Technical Report - Supporting Data and Analysis for Skagit River RFIS Appeal

**City of Burlington
City of Mount Vernon
City of Sedro-Woolley
Town of La Conner**

Skagit County, Washington

Pacific International Engineering, PLLC

Figure 1. Stewart Surveyed 1909, 1917 and 1921 Highwater Marks (in feet, MSL) in Concrete Area

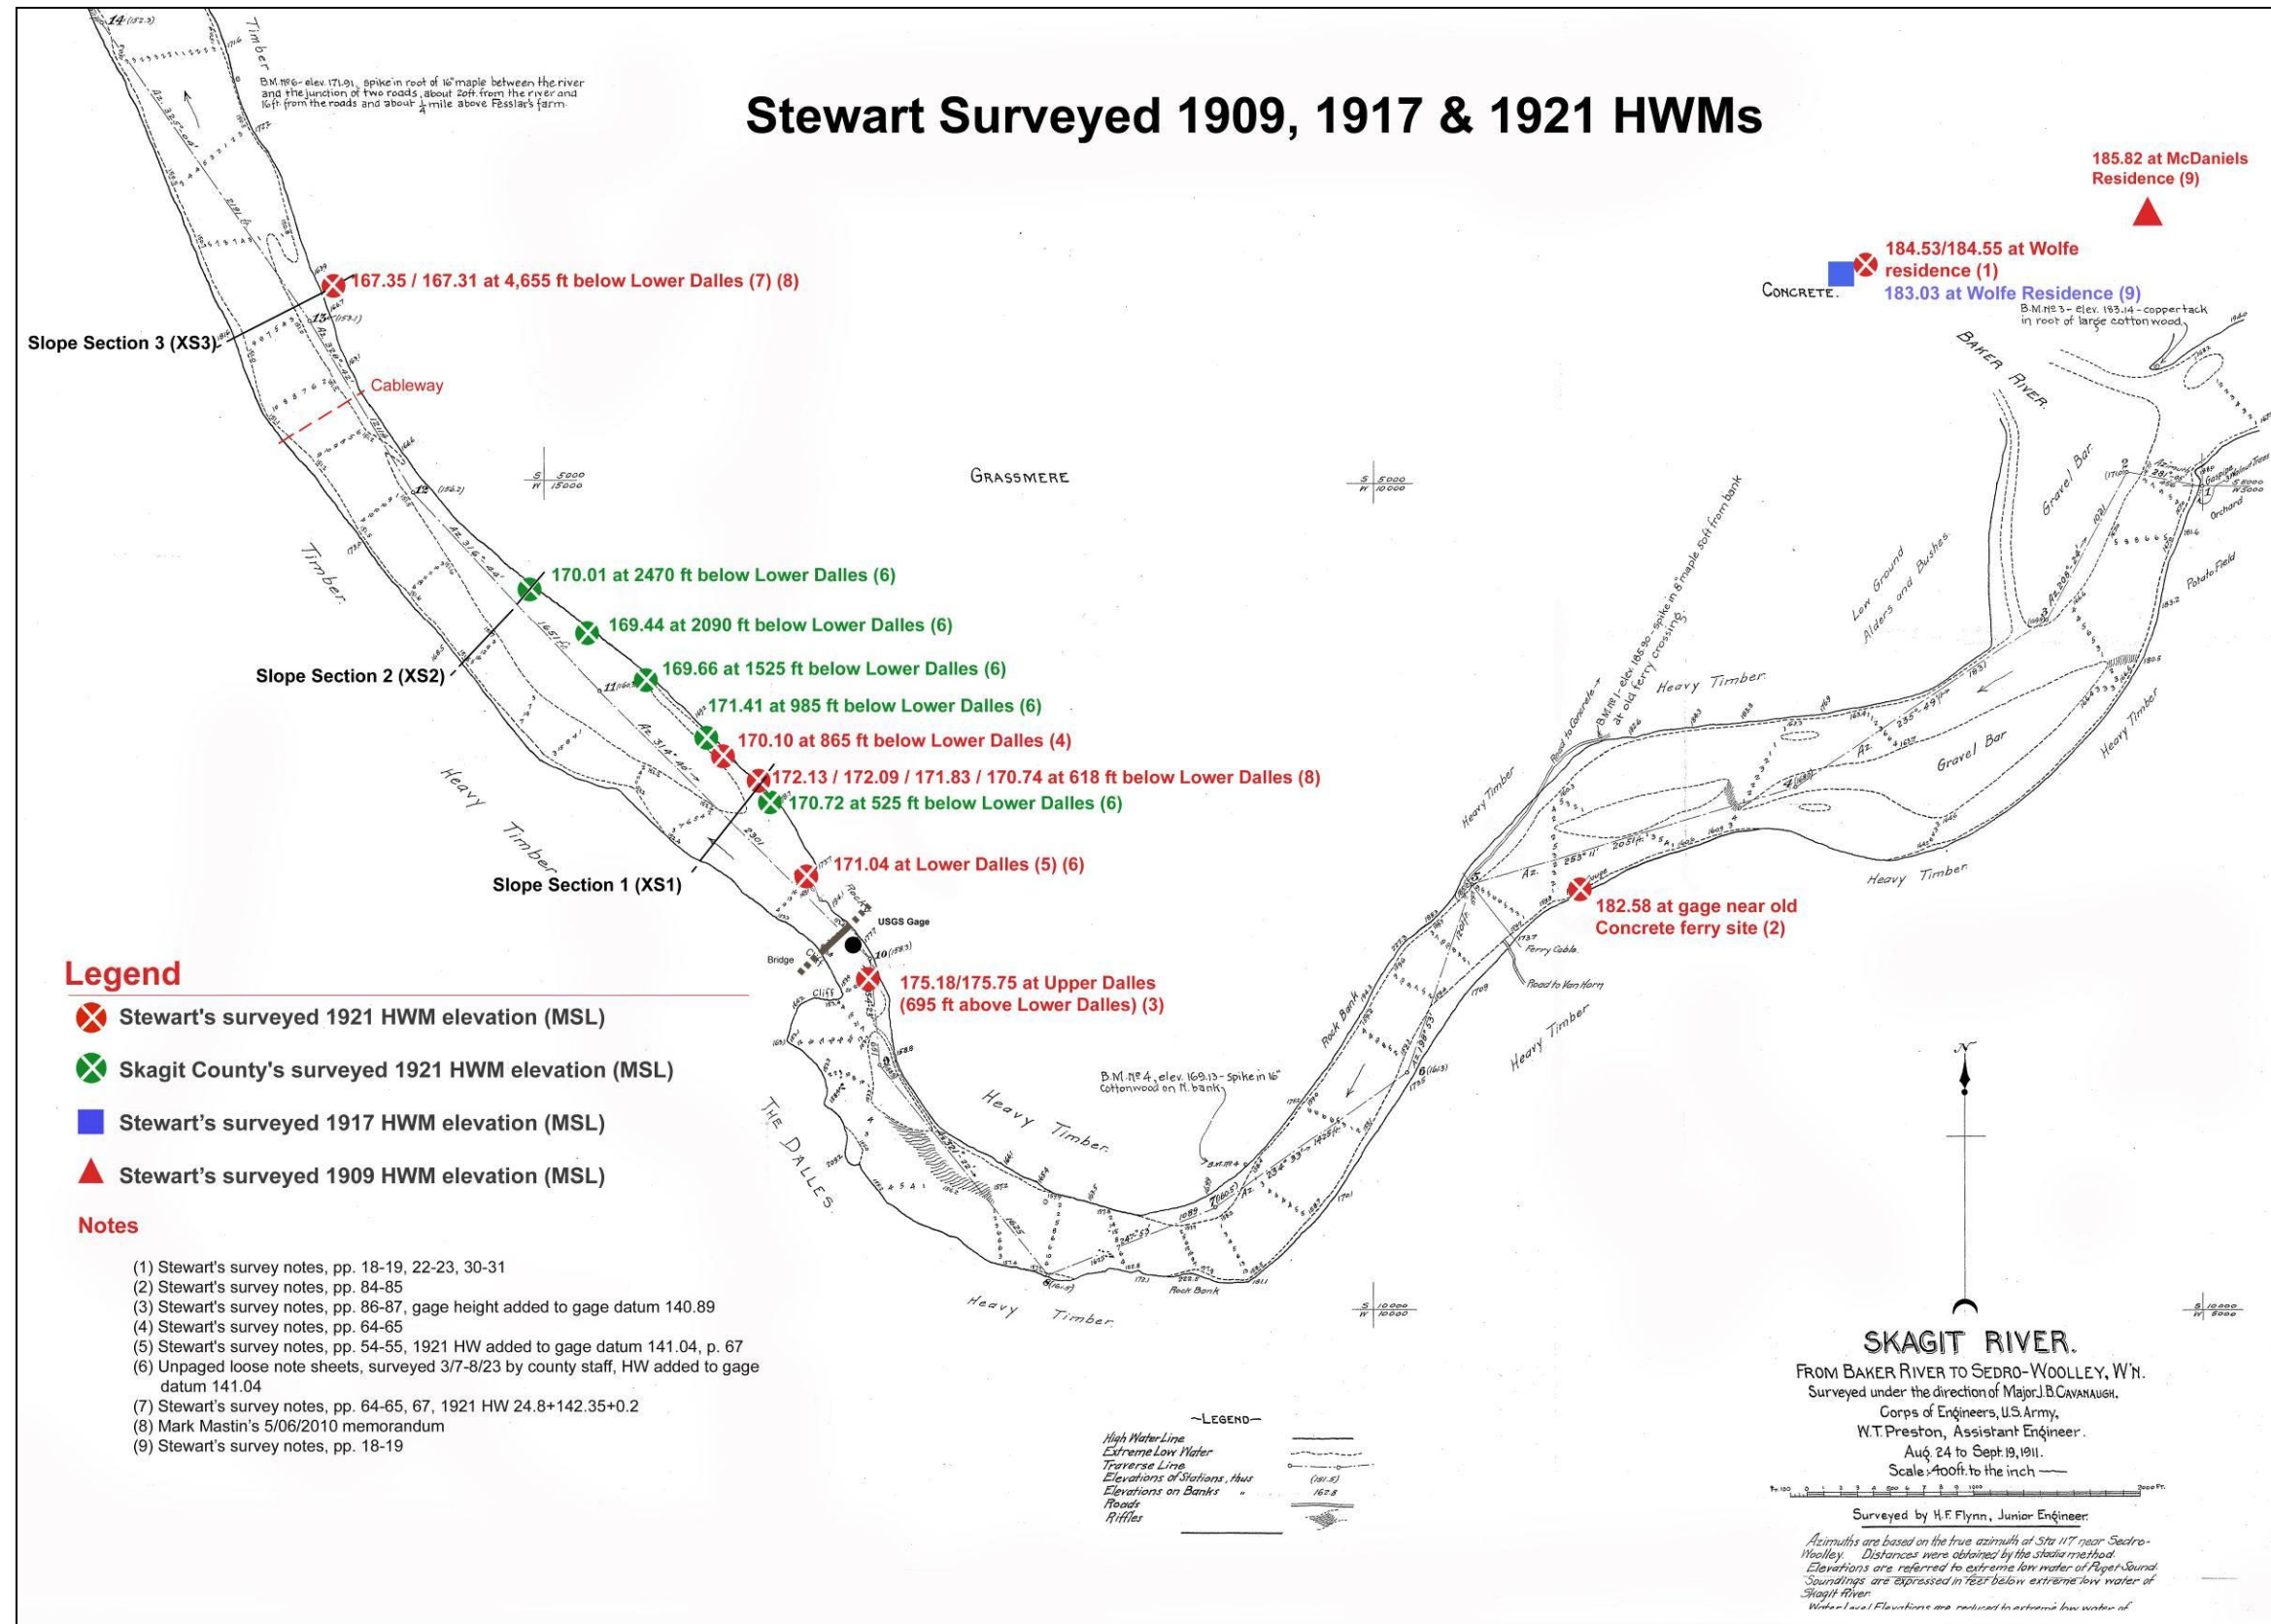
Documentation of Stewart's surveyed historical flood marks are presented in his hand-written field notes (Stewart, 1922-23). Figures 1 and 2 show the location and the water surface elevations of Stewart-surveyed flood marks (or highwater marks, HWMs) in the Concrete area and in the Hamilton-Lyman area, respectively. Figure 2 also shows over a dozen other observed 1909 and 1921 flood marks along Lyman-Hamilton Road and along the old Great Northern Railroad (GNRR) parallel to Lyman-Hamilton Road (for discussion of these flood marks, see Section 2.2.3). These flood marks correlate well with Stewart-surveyed historical flood marks in the area.

Stewart's 1921 HWMs shown in Figure 1 are 175.18 and 175.75 at the upper Dalles and 171.04 at the lower Dalles, indicating a drop of 4.14 and 4.71 feet (averaging 4.5 feet) at the crest of the 1921 flood between the upper and the lower Dalles. Stewart noted that the upper Dalles is 695 ft above the lower end of the Dalles (Stewart's survey notes, p. 62).

Figure 8. Slope Section XS3 – Skagit River near Concrete, WA

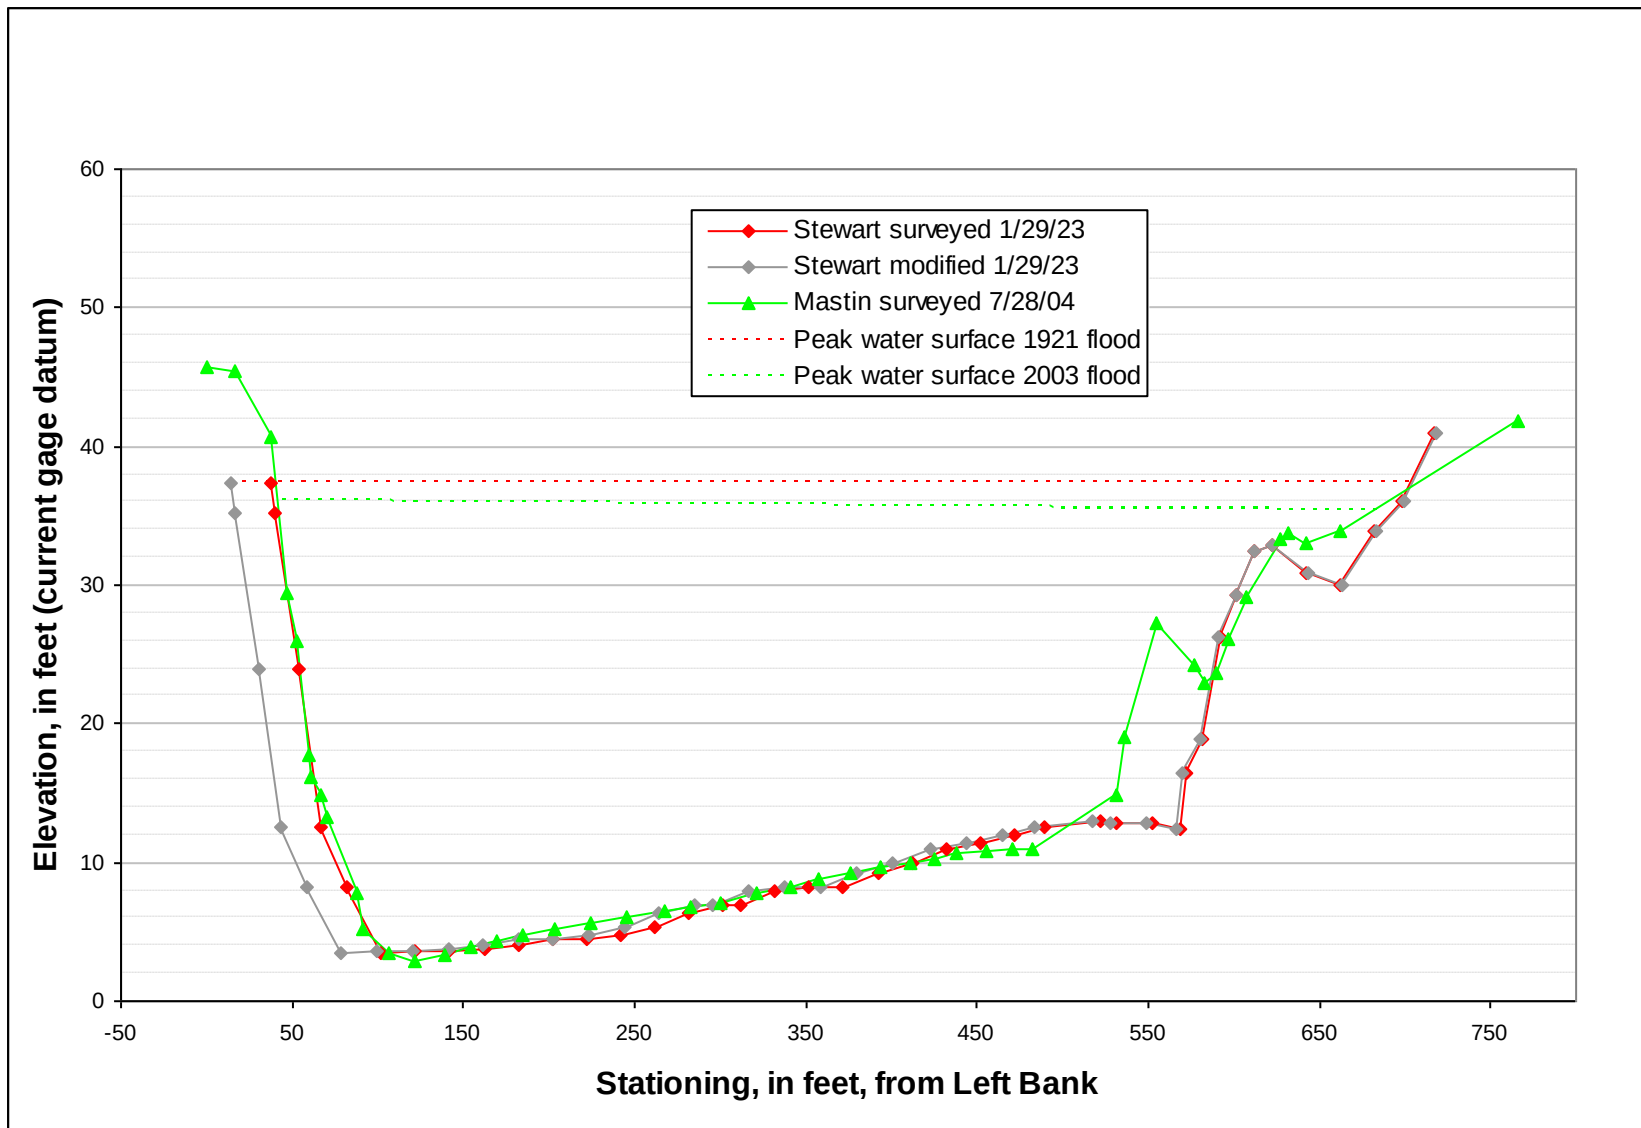
Figure 8 shows plots of Stewart's originally surveyed and later-modified lower slope section. In 2004, the USGS (Mastin and his field crew) surveyed this section. The USGS 2004-surveyed lower slope section is also shown in the figure for a comparison. This comparison indicates that Stewart's originally surveyed section appears accurate, matching the channel width and bottom elevations with the 2004-surveyed section better than his modified section. This comparison assumes that the 1923 and 2004 surveys are approximately at the same location, and that the change in cross section from 1923 to 2004 at this location is not significant.

As previously discussed (Section 2.2.5) and shown in Figure 6, it is our opinion that Stewart's originally surveyed XS3 is more accurate than his later-modified XS3. Stewart assumed his survey rope was stretched by approximately 5% when he was surveying XS3 and went ahead to modify his originally surveyed XS3 without an actual verification of his assumption. Stewart's assumption is incorrect based on a comparison with the USGS 2004 surveyed section at XS3 location as shown in Figure 8.

Figure 9. 1921 and 2003 flood high water marks surveyed by Stewart (in 1922-23) and USGS (in summer 2004)

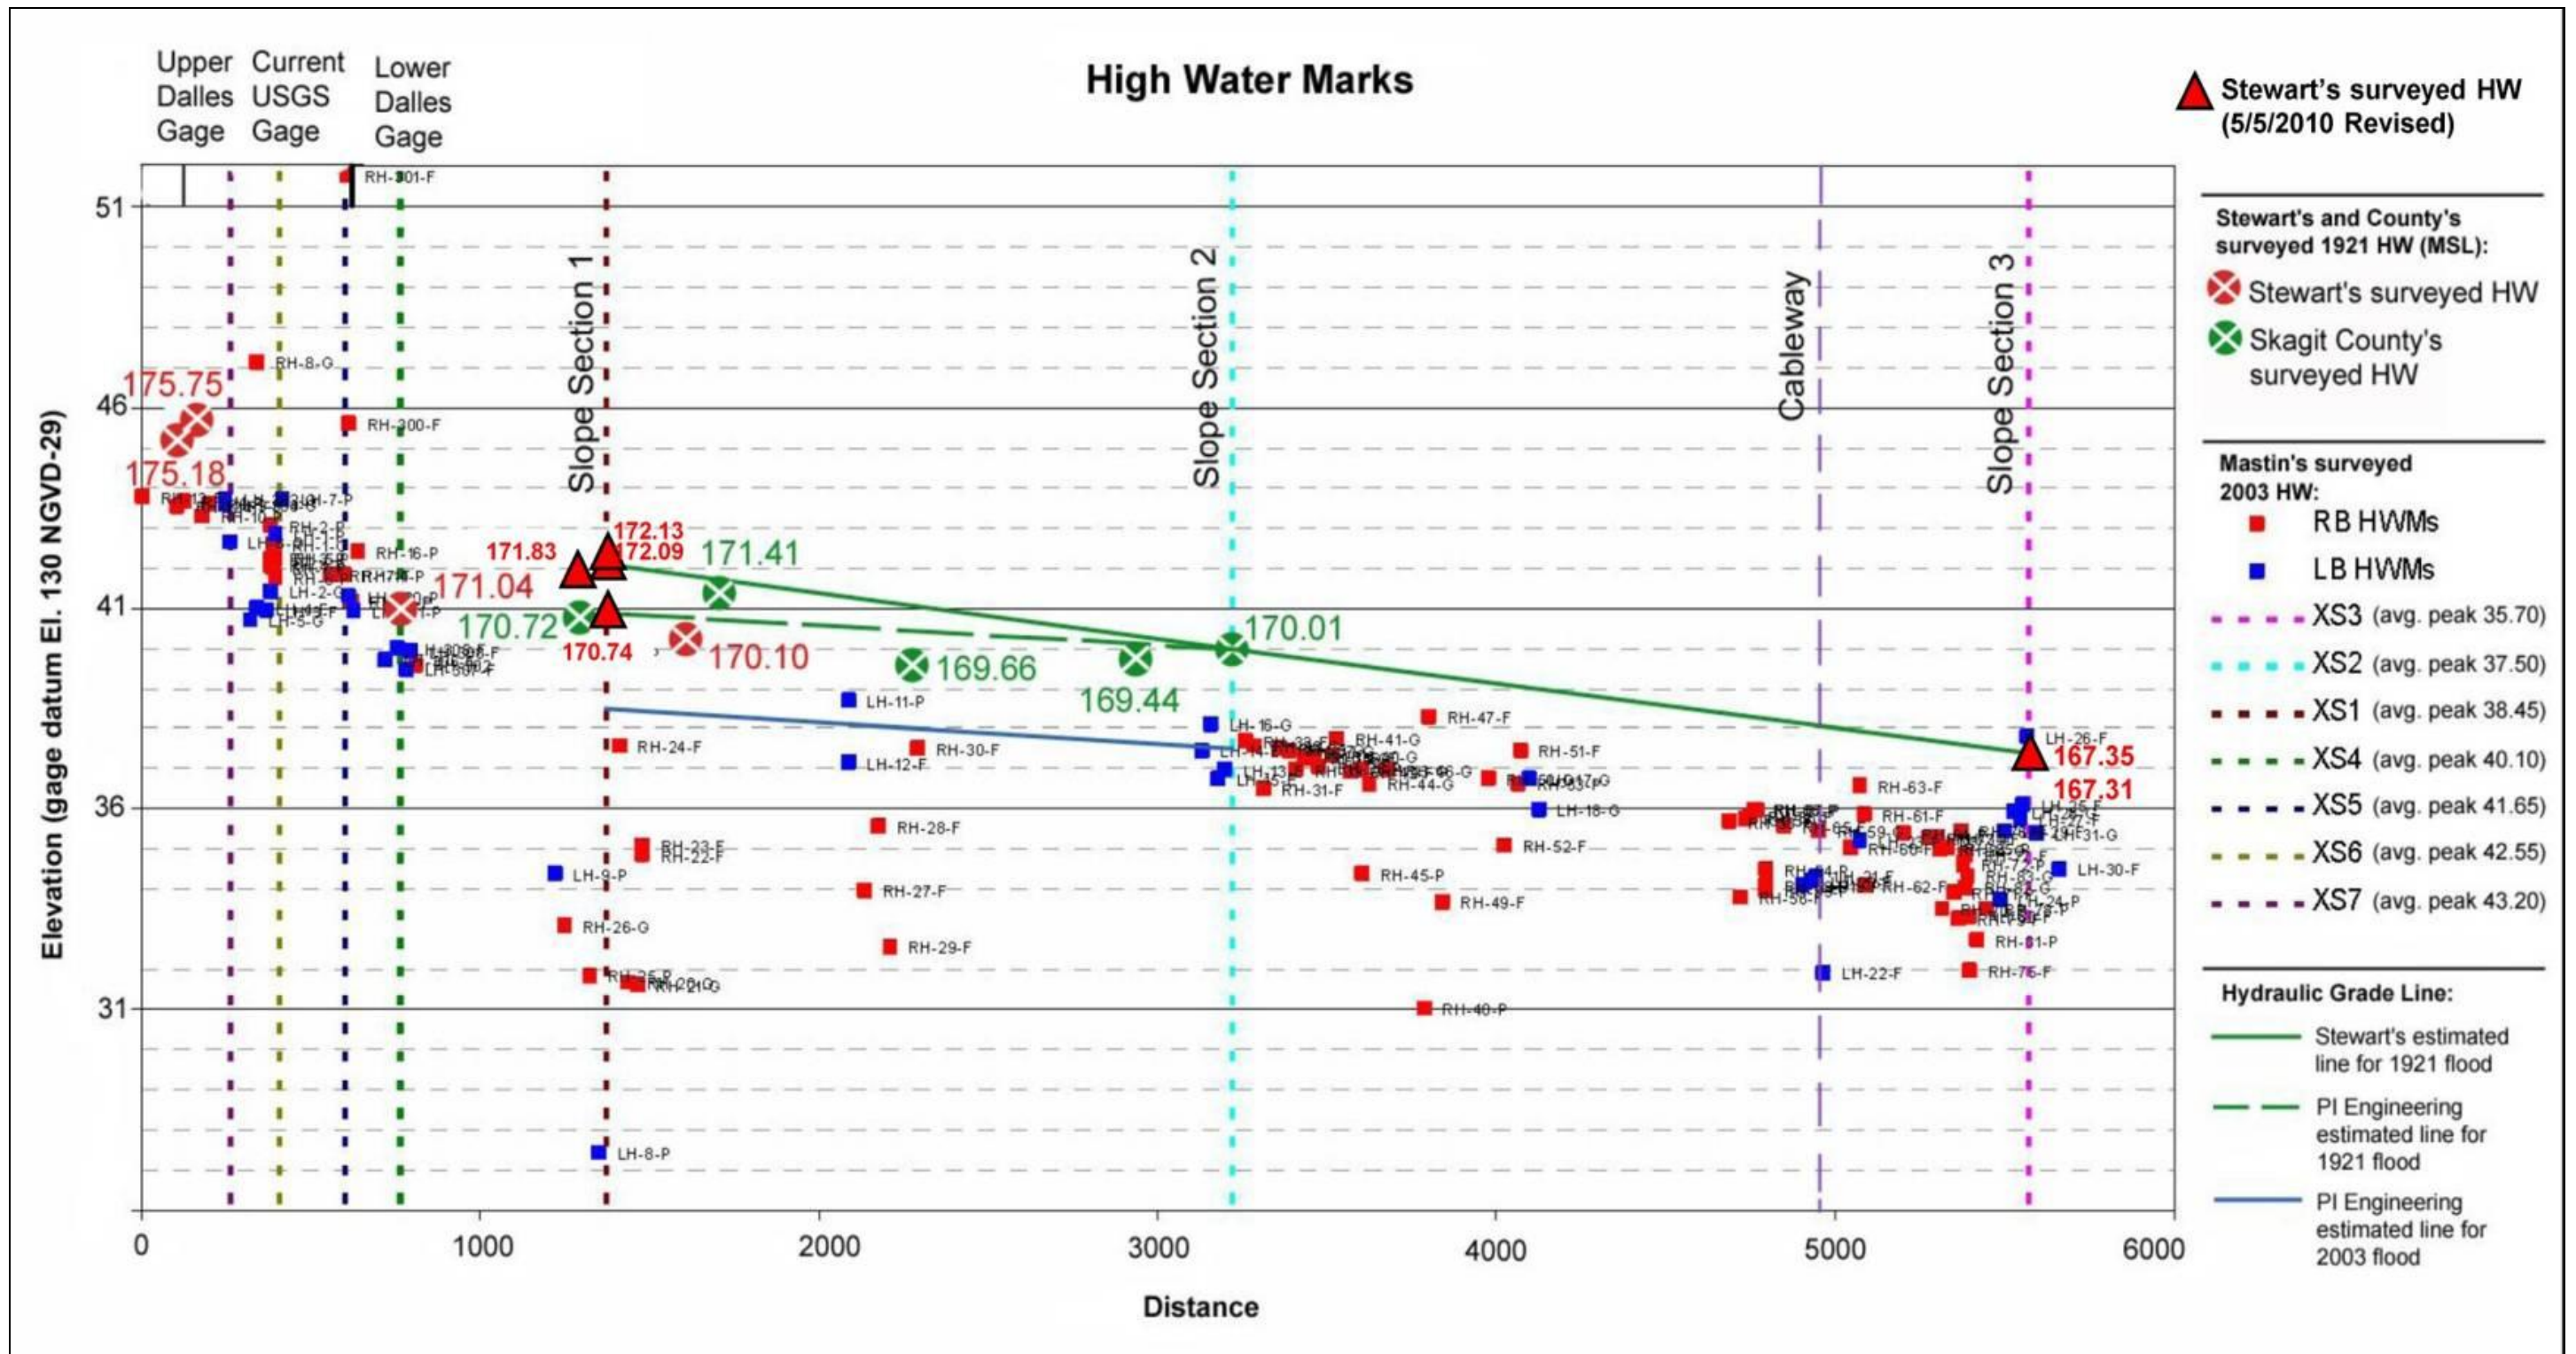
Figure 9 shows elevation plots of Stewart-surveyed 1921 HWMs (see Figure 1 for HWM location) and USGS-surveyed 2003 HWMs (surveyed in summer 2004 and provided by Mastin in the spreadsheet Concrete_03_SAM.xls) in the Dalles and slope-area reaches. The slope sections XS1 and XS2 are located below the Dalles at 618 and 2,479 feet, respectively (Stewart 1923, Exhibit B, p. 2). Stewart’s suggestion would exclude the use of the HWM data (particularly, the three higher data points, 171.83, 172.09 and 172.13, due to the residual of “the velocity head gained in The Dalles”) at XS1 located within the Stewart suggested 700 foot distance and not far enough below the Dalles to dissipate “all of the velocity head gained in The Dalles”.

Excluding the HWMs at XS1 and using the other HWMs below XS1, we interpolated a fall of the 1921 water surface between XS1 and XS2 to be 0.85 foot. The corresponding hydraulic grade line slope between XS1 and XS2 was then calculated to be 0.000457 ($= 0.85/1860$). As shown in Figure 9, the 2003 flood HWMs also support the flatter hydraulic grade line slope between XS1 and XS2. Using the USGS-estimated average peak elevations 38.45 and 37.50 provided in the spreadsheet and listed in Figure 9, we estimate the hydraulic grade line slope between XS1 and XS2 for the 2003 flood to be 0.000511 ($= (38.45 - 37.50) / 1860$), which is very similar to the above-estimated slope of 0.000457 for the 1921 flood.

The hydraulic grade lines used by Stewart for the upper and lower slope-section reaches (XS1–XS2 and XS2–XS3) are plotted on Figure 9, as well as those estimated by PI Engineering for the upper slope-section reach (XS1–XS2). Our comparison assumes no revision to Stewart-used lower
